PORTION OF SE QUARTER OF SEC 27, TWN 20 N, RGE. 4 E, W.M.
CITY OF PUYALLUP, PIERCE COUNTY, WASHINGTON
SITE PLAN

PRRWF20240390

SITE PLAN

FORTRESS - PUYALLUP

Sheet: **C4** of **34**

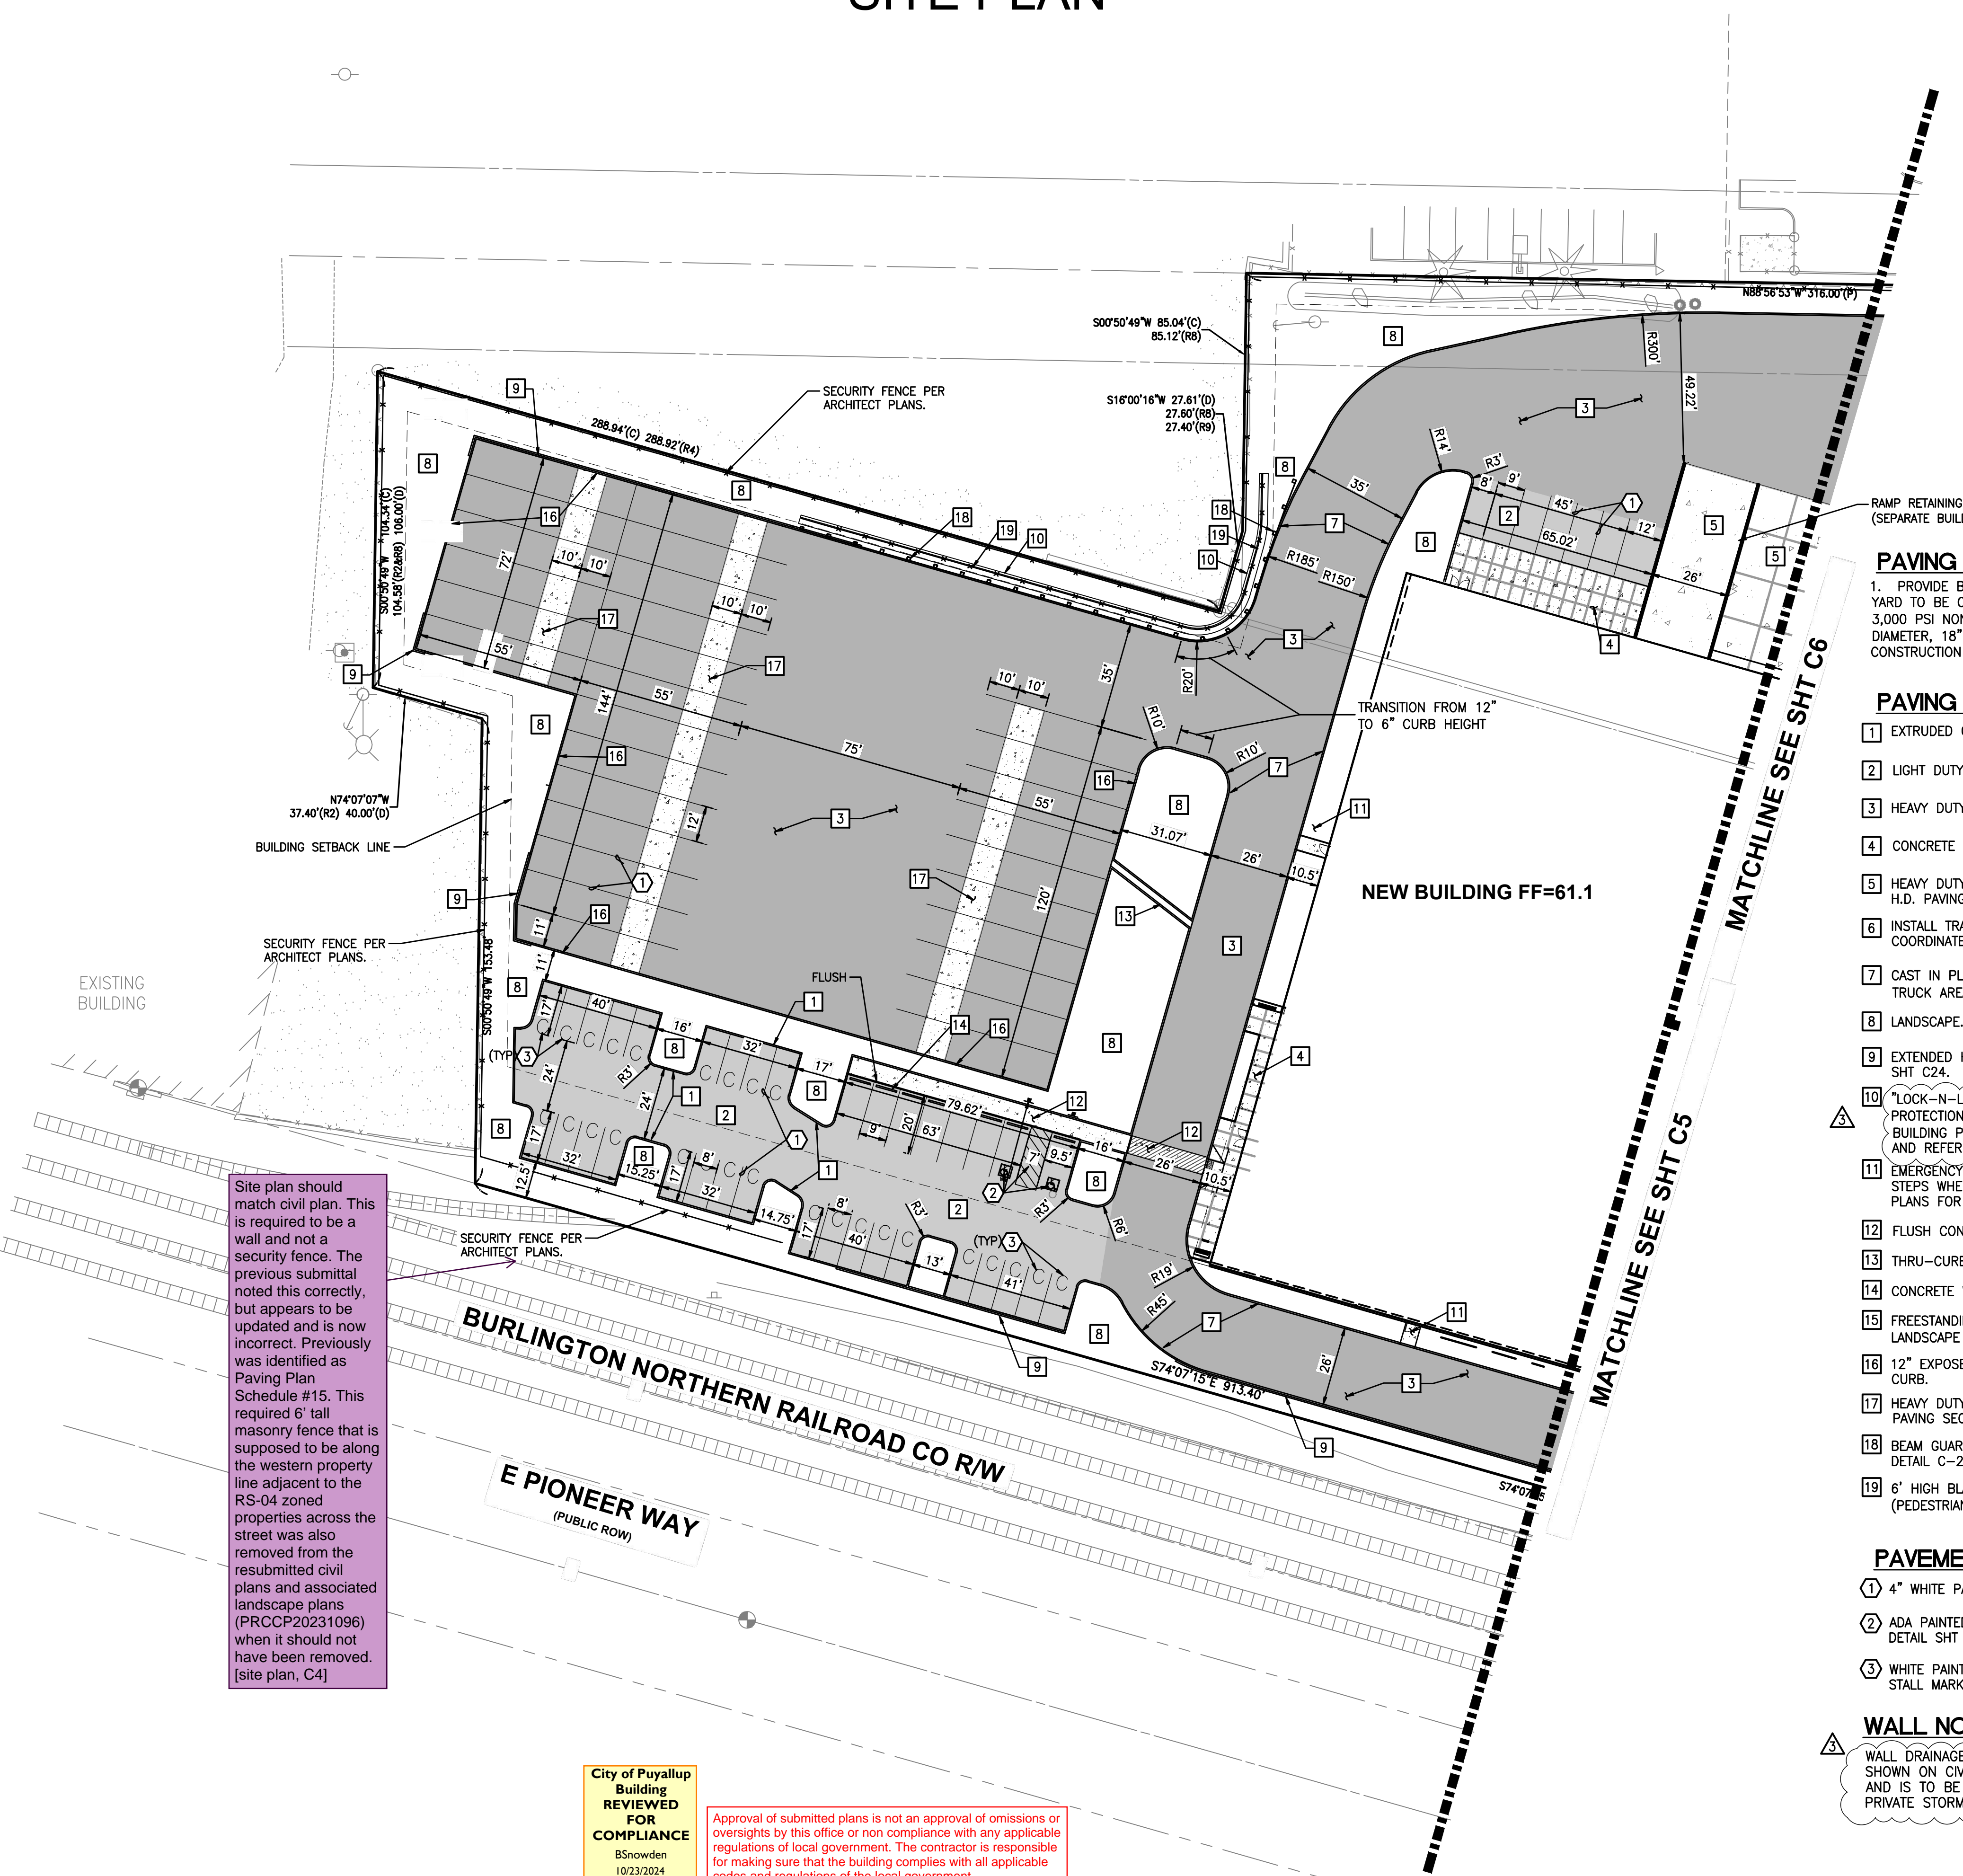
Site plan should match civil plan. This is required to be a wall and not a security fence. The previous submittal noted this correctly, but appears to be updated and is now incorrect. Previously was identified as Paving Plan Schedule #15. This required 6' tall masonry fence that is supposed to be along the western property line adjacent to the RS-04 zoned properties across the street was also removed from the resubmitted civil plans and associated landscape plans (PRCCP20231096) when it should not have been removed. [site plan, C4]

Steps shall be taken to prevent drainage onto adjacent lots and below and beyond the toe of the wall.

The City does not review, approve, authorize, or permit work in the BNSF Railway right-of-way. The applicant and permit holder are responsible to obtain the necessary permits from the jurisdictional agencies to complete this work. A BNSF Railway Company Pipeline or Wire Line permit may be required. The applicant or permit holder shall present a copy of the BNSF permit upon request of the City Inspector.
